CITY OF TONTITOWN PLANNING OFFICE

Meeting: **February 26, 2019**
Project: **La Bodega Wholesale Foods**
Planner: Courtney McNair

- i. **CONDITIONAL USE PERMIT REQUEST**
- ii. **PRELIMINARY LARGE SCALE DEVELOPMENT PLAN APPROVAL REQUEST &**
- iii. **WAIVER REQUEST**

West of 585 Jean Mary Drive
Parcel # 830-37833-000

A2.1
COLOR ELEVATIONS

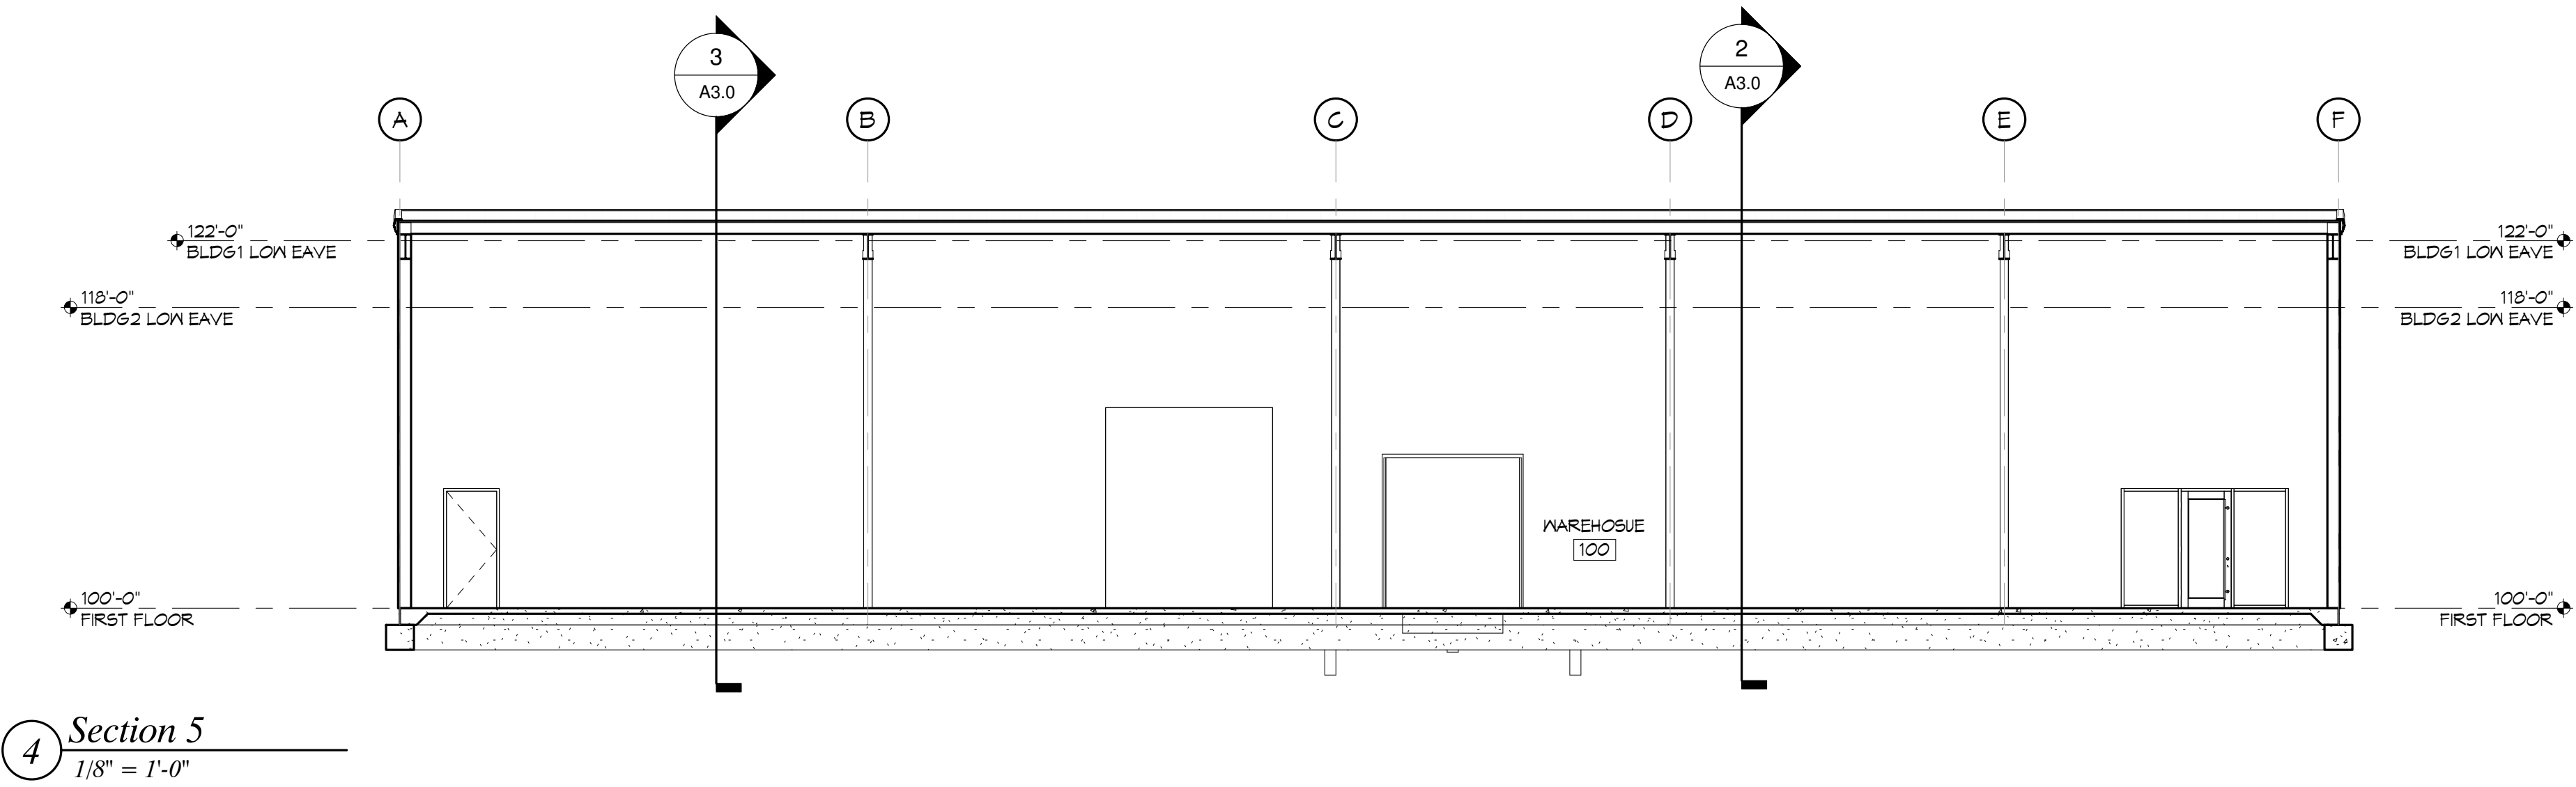
Architectural plans were submitted. The plans submitted do not meet the 75% masonry requirement, they do not meet the roof line articulation requirement, only one architectural feature is provided at the entrance (two are required), and they are only showing one architectural feature for the front façade (three are required).

Architectural plans were submitted. The plans submitted do not meet the 75% masonry requirement, they do not meet the roof line articulation requirement, only one architectural feature is provided at the entrance (two are required), and they are only showing one architectural feature for the front façade (three are required).

The applicant is requesting a waiver from the required architectural elements. The surrounding buildings are primarily blue metal panel. The proposed building will have a neutral color tone and have a split face block wainscot on the street façade. The applicant states that the “added material and natural color combination will enhance the area while still being in keeping with the surrounding architecture.”

However, staff does feel the building should incorporate the remainder of the required architectural features, and will recommend that the Board include these if the waiver is granted. This serves to enhance the area, and provide precedent for future businesses that are similar, while remaining reasonable for this type of development.

STAFF RECOMMENDATION: Staff recommends approval of the waiver allowing less than 75% masonry façade with conditions to require the additional architectural elements.

SITE & UTILITY PLAN

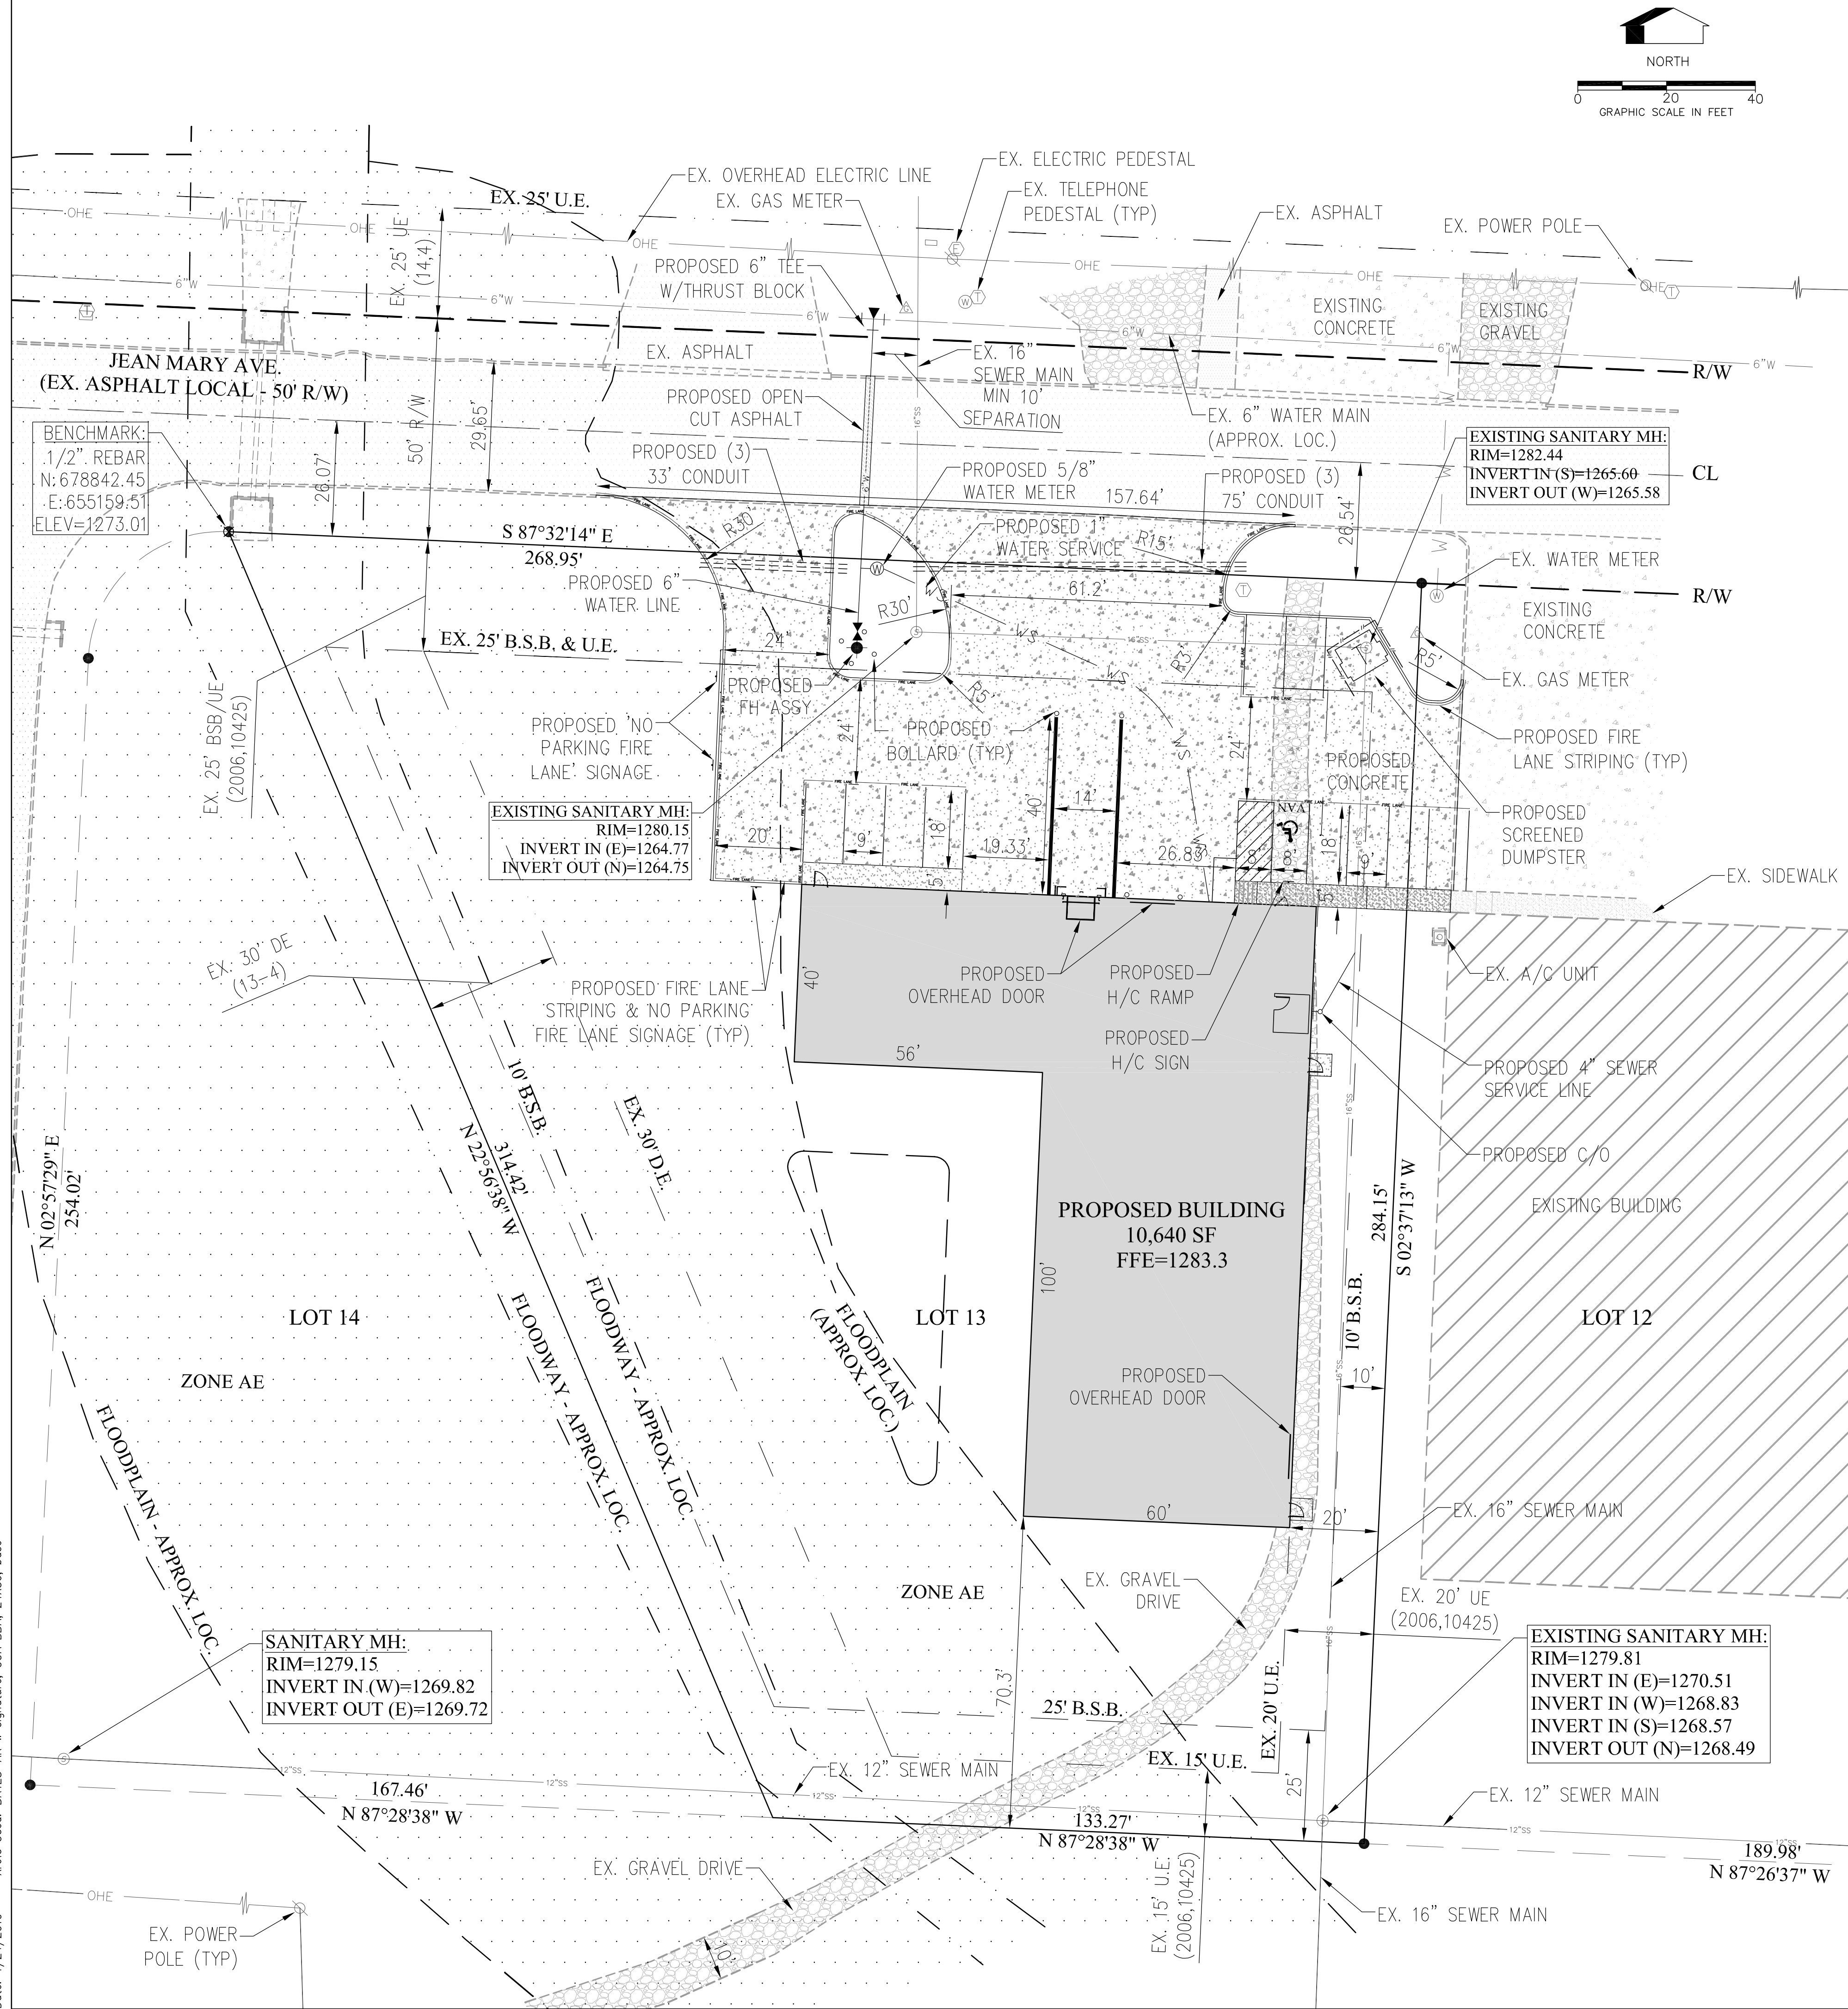
There is one fire hydrant shown on the plans.

The fire access drive is 24 feet wide with an additional 62-foot-wide entrance proposed. All turns have the required radius for fire apparatus access. "No Parking" signs are shown on the plans. All interior drives must meet the required compaction rating to support emergency vehicles.

This proposal has all required parking located in front of the building and connected to the existing building to the east. The applicant is requesting a waiver from this requirement due to the floodplain. They are attempting to keep as much development out of the floodplain as possible.

4. Water and Sewer plans shall be approved prior to construction.
 5. "No Parking" signs shall be placed per the Fire Marshal.
 6. A Knox box for the building is required.

9. All interior drives shall meet the required compaction rating to support emergency vehicles.
 10. Correct all comments from the City Engineer prior to Construction Plan approval.

STAFF RECOMMENDATION: Staff recommends approval of the waiver to allow all parking to be placed on the street side of this property.

LA BODEGA WHOLESALE FOODS
LARGE SCALE DEVELOPMENT PLAN
LANDSCAPE PLAN
TONTITOWN, ARKANSAS

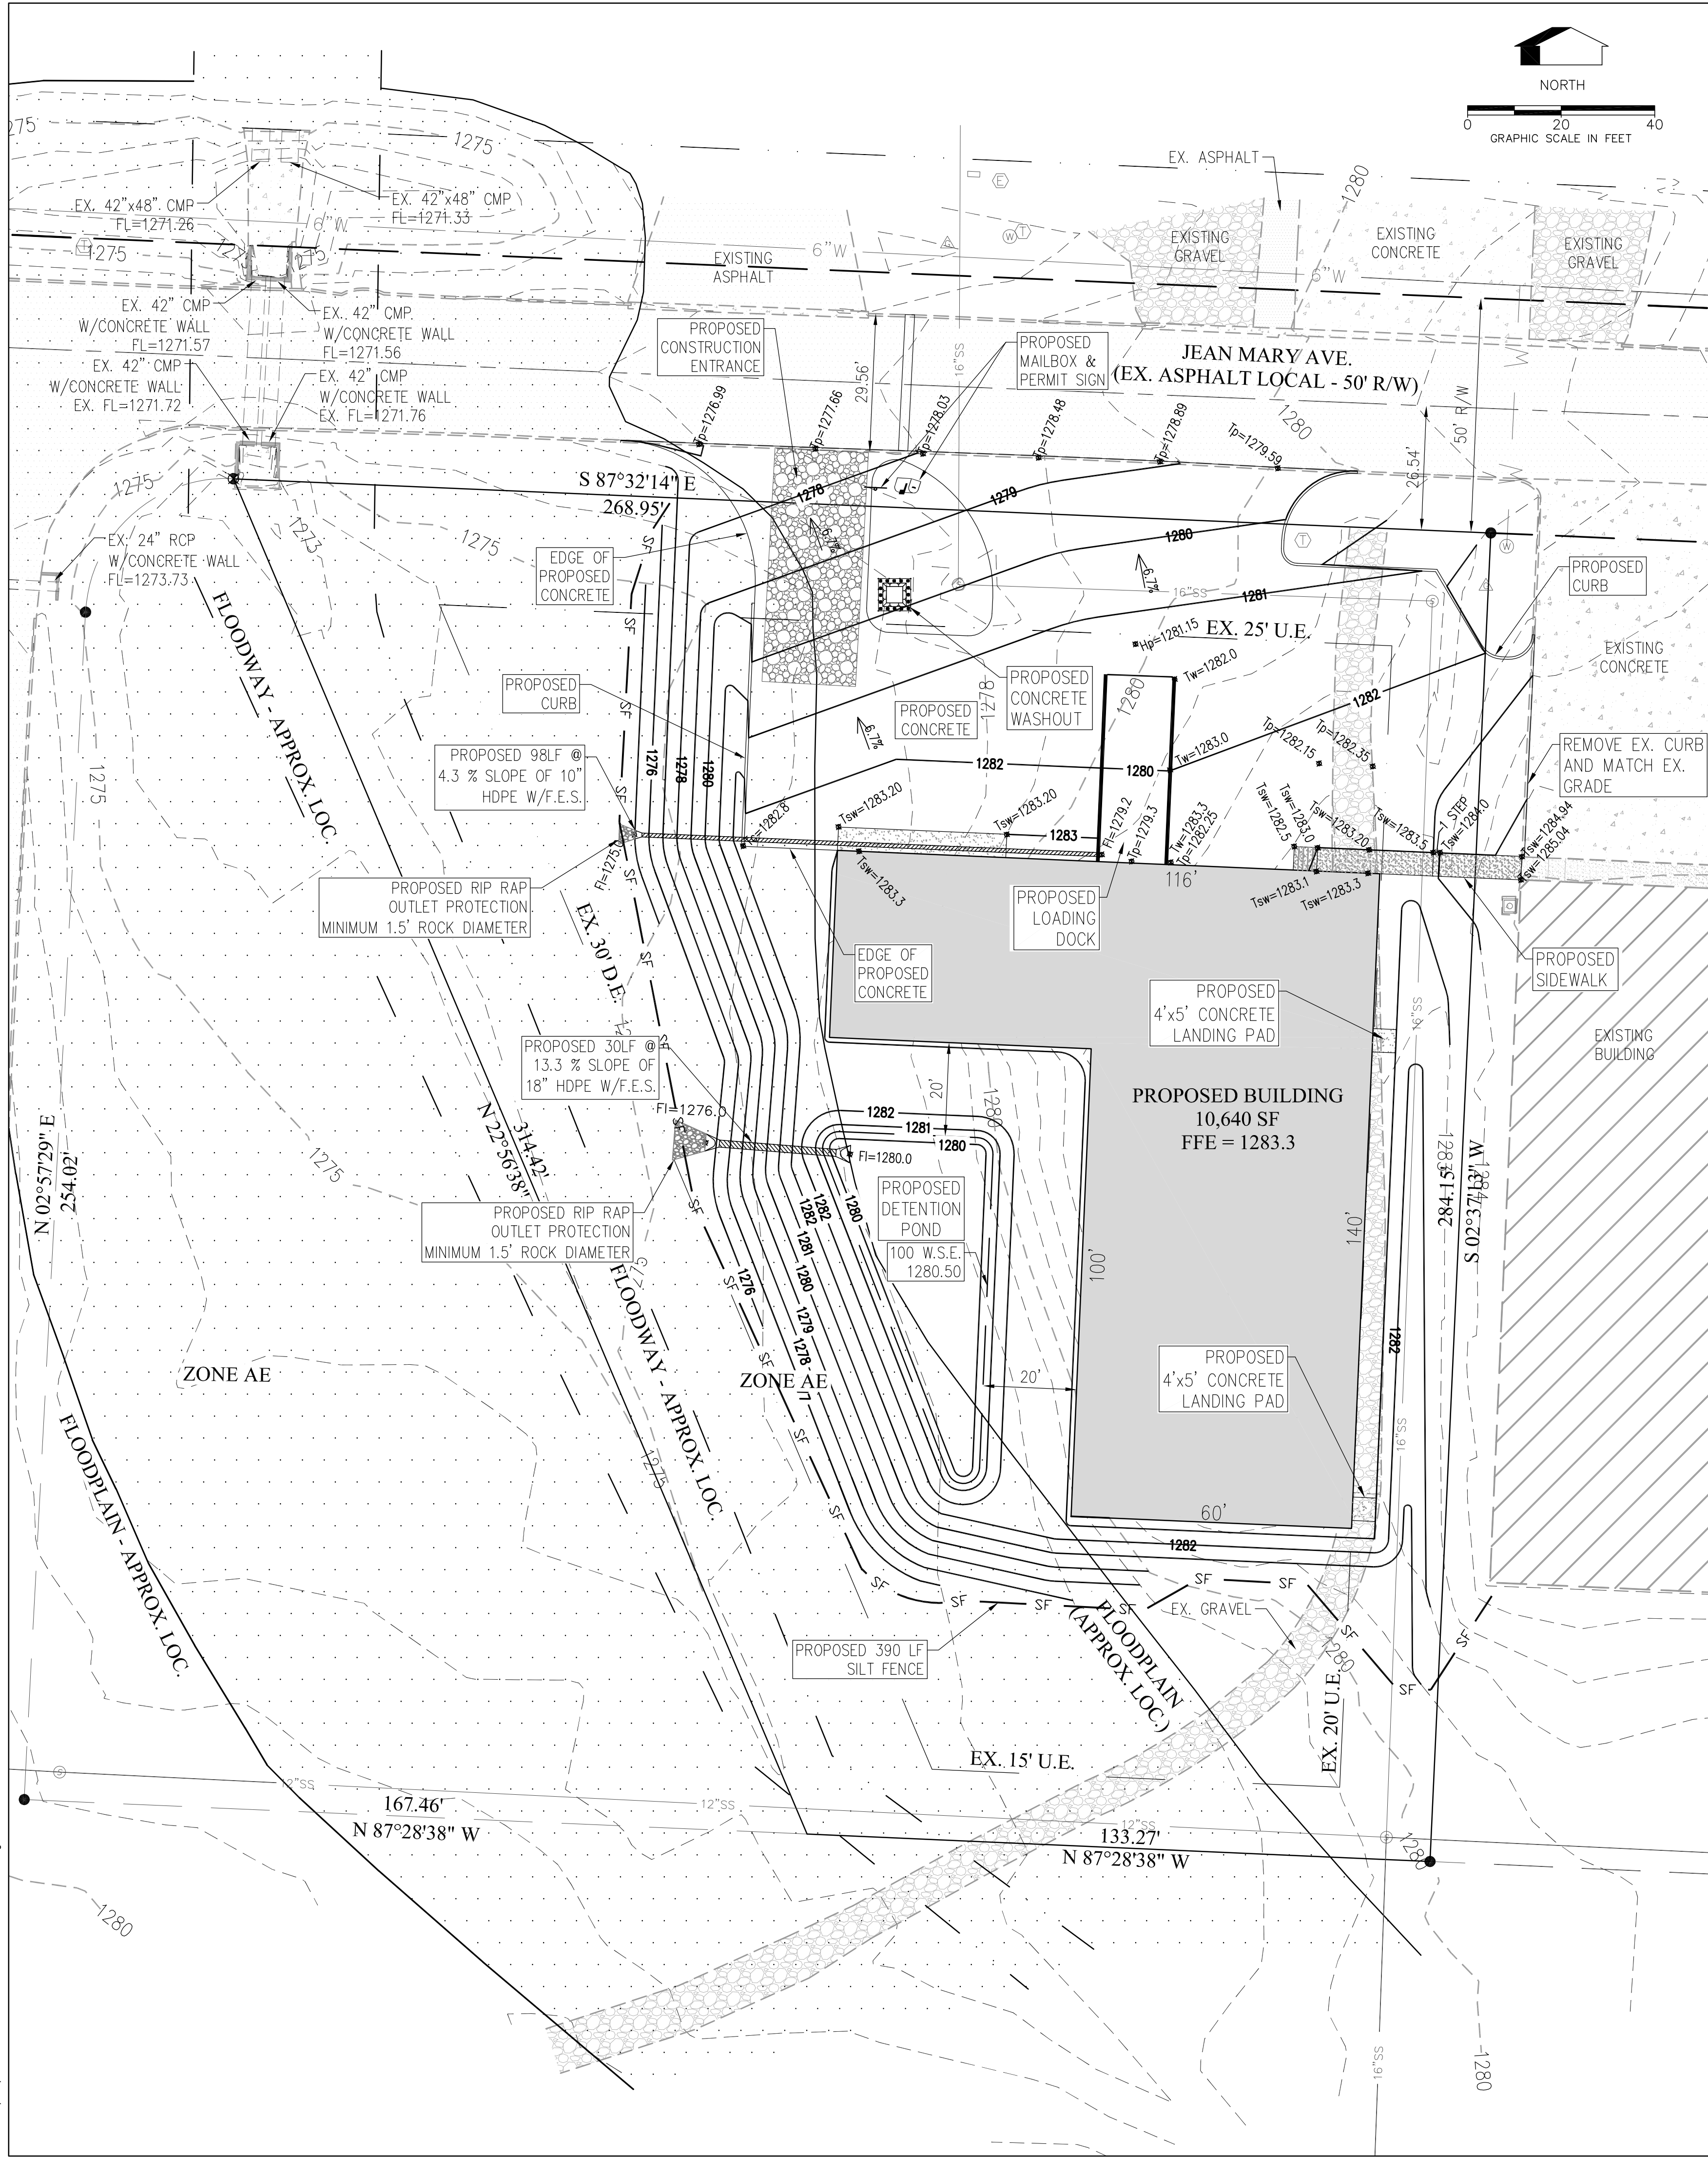
- *Provide protection for water quality, reduce erosion, heat and glare- **The applicant is providing very little landscaping.***
- *Retain existing trees where possible-**all existing trees are to be removed.***
- *Screening and buffering for uses which are marginally compatible-**all surrounding uses are compatible***
- *Provide for beautification and enhancement of the property- **The applicant is providing very little landscaping.***

STAFF ANALYSIS: The applicant is providing no additional landscaping beyond the basic required for a large-scale development. There is no adjacent building that necessarily needs additional screening. With a CUP, the Board has the authority to require additional landscaping if it is deemed necessary.
